**BLAINE COUNTY BOARD OF COMMISSIONERS**  
**PUBLIC HEARING on September 6, 2022 at 2:30 p.m.**

<b>REGARDING AN APPLICATION OF:</b> Briana Swette for a Stream Alteration Permit (SAP) on the Big Wood River.	<b>Staff Report</b> Kristine Hilt Dated August 24, 2022
--	---

**REQUESTED ACTION:** Public hearing and consideration of an application by Pale Gem, LLC (Briana Swette) to stabilize an eroding streambank on the Big Wood River. Project activities include stabilizing 662 linear feet of bank by constructing large wood structures, revegetating, and discharging approximately 383 cubic yards of rock riprap to halt further erosion. This project is located within Section 1, T1N, R18E, B.M., Blaine County and is zoned Residential Agricultural (R-5) with areas of Floodplain (F), Floodway (FW), Riparian (R) and potential Wetland (WE) Overlay Districts.

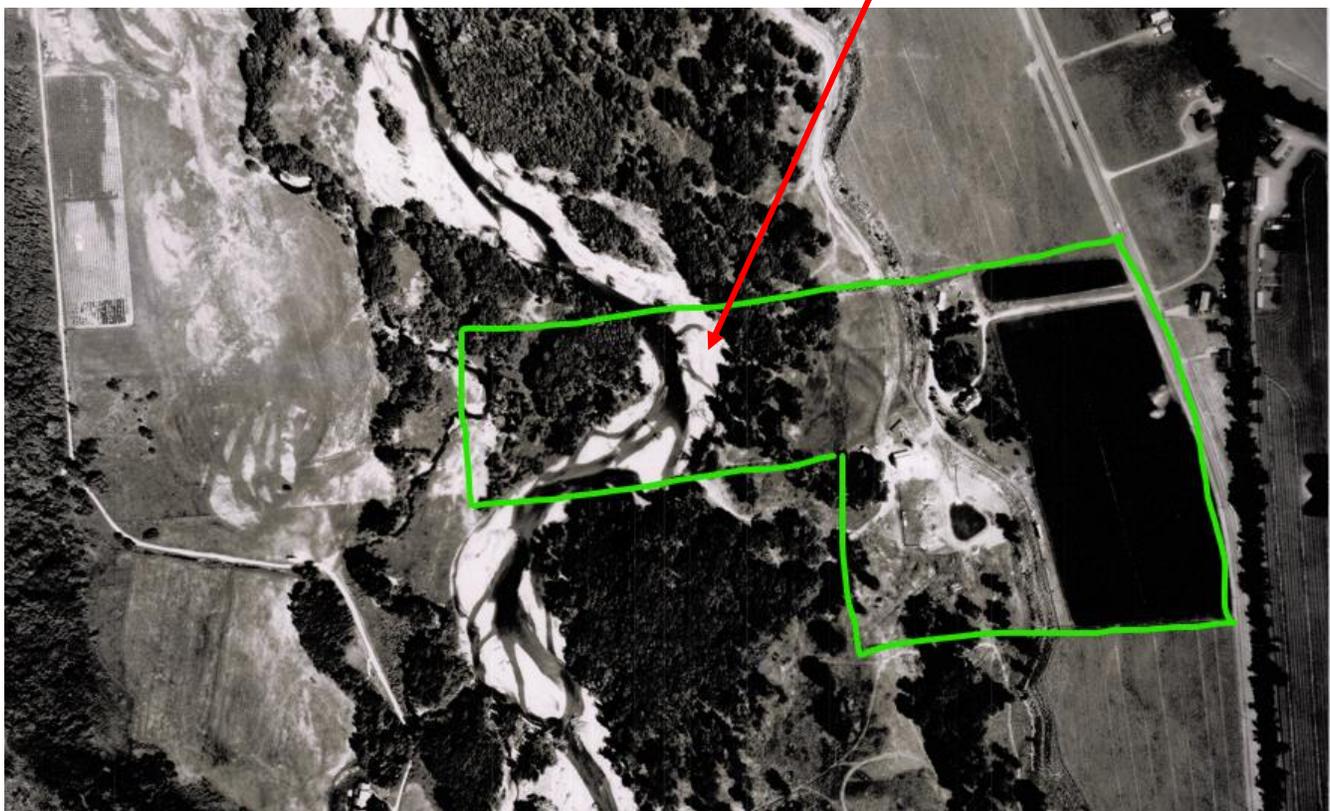
6. **HISTORICAL RIVER DATA:** According to historical aerial imagery on file, the river has reclaimed a historic channel visible below in 1943 imagery:

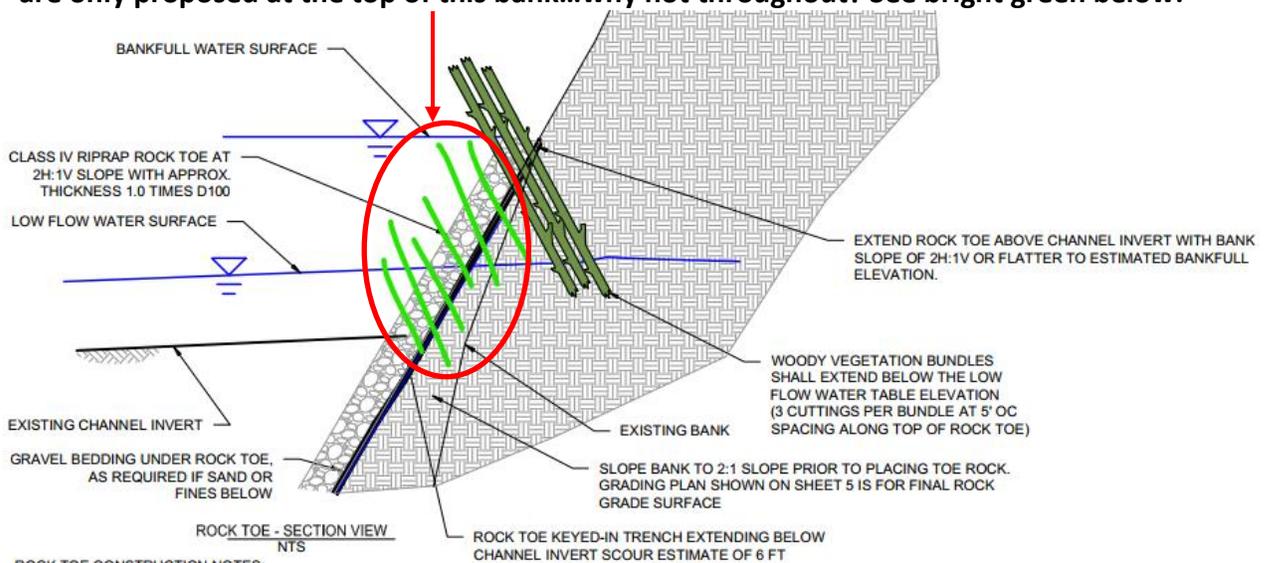
- The County Engineer did not comment on the bankfull elevation so staff assumes that there is an agreement on this calculation.
- The design team should consider whether or not simply revegetating the bank in between the debris jams can be a viable solution to meeting project goals. Limiting the amount of rock on the face of the banks of the Big Wood River would reduce downstream impacts associated with bank hardening (i.e. increased potential of erosion/sedimentation in untreated reaches.) Installation of rock riprap would also remove critical habitat (overhanging banks and cover) for fish.

- The design team should consider whether rock riprap implementation is necessary all the way up to the bankfull elevation. The majority of our annual flows stay below this elevation, which means that the water will almost constantly be in contact with a hardened rock face. Plantings are only proposed at the top of this bank...why not throughout? See bright green below:

5. The applicant shall revegetate the entire bank face with native woody shrubs and trees, including the rock riprap areas in the downstream reach of this project area.
6. The applicant shall notify the County's Floodplain Manager prior to start of work.
7. The county shall receive an annual report for a period of 3 years. This report is to include information regarding the current state of the constructed wood structures, vegetation, and rock riprap. The report shall also address each of the project goals.
